Ser. No. 10/645,213
Amdt. dated June 21, 2005
Reply to Office action of January 21, 2005

Amendments to the Drawings

Remarks/Arguments

FIG. 5A

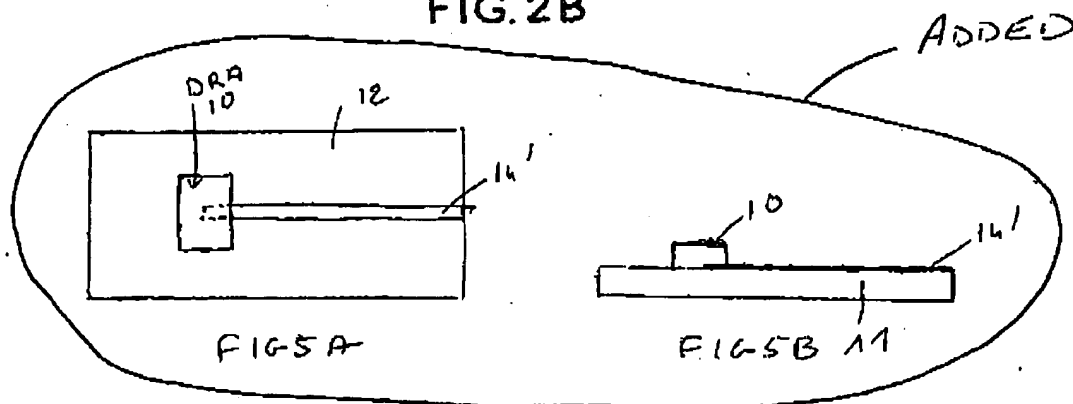
The Examiner has objected to the drawings under 37 CFR 1.83(a) as not showing all the features of the invention specified in the claims. Figures 5A and 5B have been added to show the features claimed in claim 4. These figures are fully supported by claim 4 and the paragraph beginning at page 5, line 14. No new matter has been added.

The attached sheet of drawings includes the addition of Figures 5A and 5B. This sheet, which includes Fig. 1, 2A, 2B, 5A and 5B replaces the original sheet including Fig. 1, 2A, and 2B. The addition of Figures 5A and 5B adds no new matter to the application.
